Amendments to the Drawings

The attached replacement sheets of drawings includes changes to FIGS. 3, 4B, and 5A and replaces the original sheets 2/7 and 4/7.

2/7

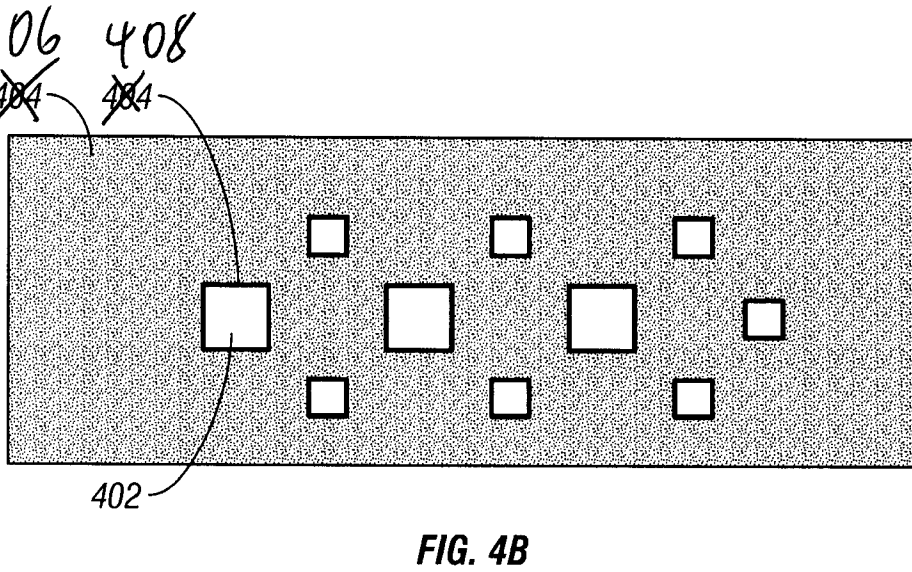
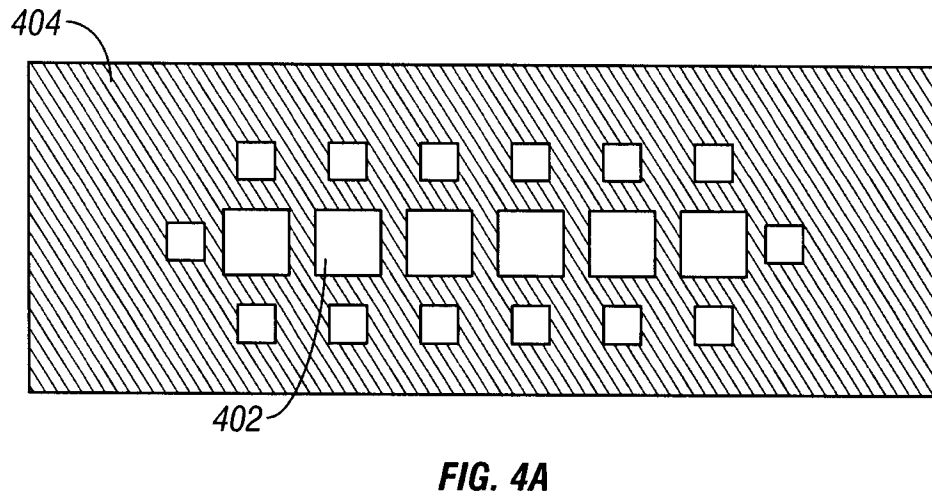
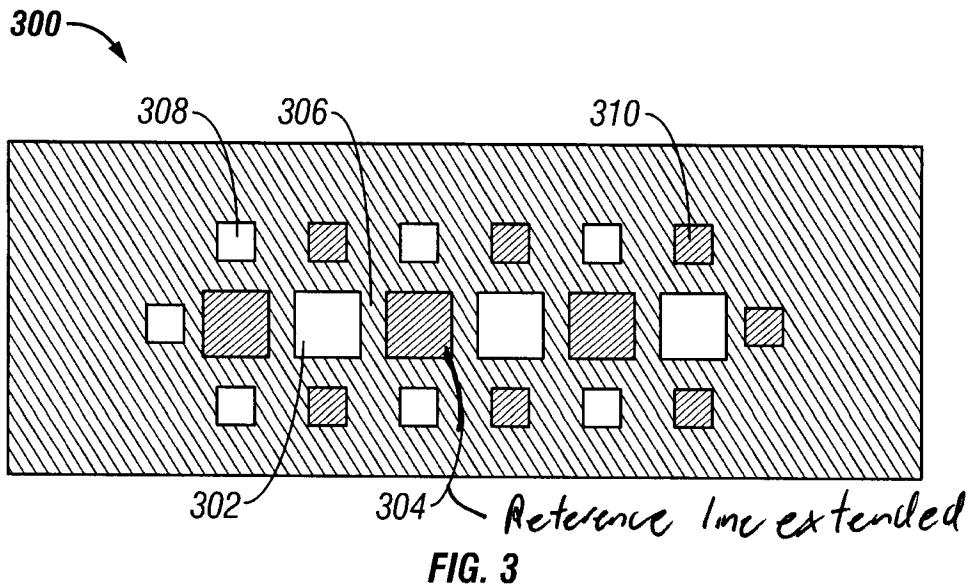
In FIG. 3, the reference line for reference numeral "304" has been extended to reach a primary pi aperture, as described in para. [0020].

In FIG. 4B, the reference numeral "406" has been used to indicate resist, as described in para. [0021]. Also, inadvertent duplication of reference numeral "404" has been corrected by denoting the open apertures with numeral "408." This change has also been made in the specification.

FIG. 5A

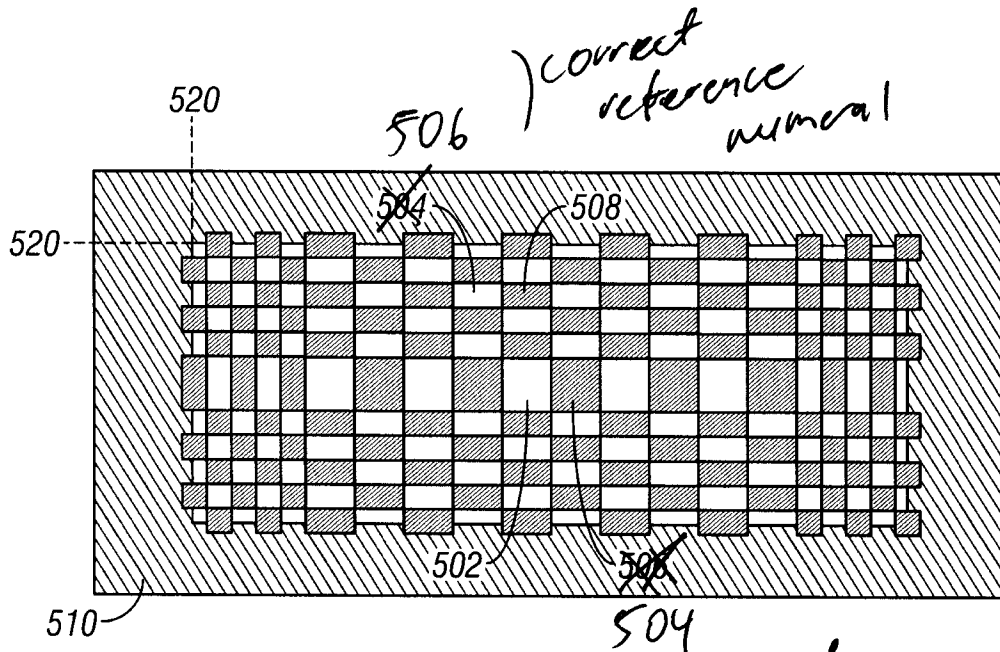
In FIG. 5A, the inadvertent switching of reference numerals "504" and "506" has been corrected, an accordance with paragraph [0025] of the specification.
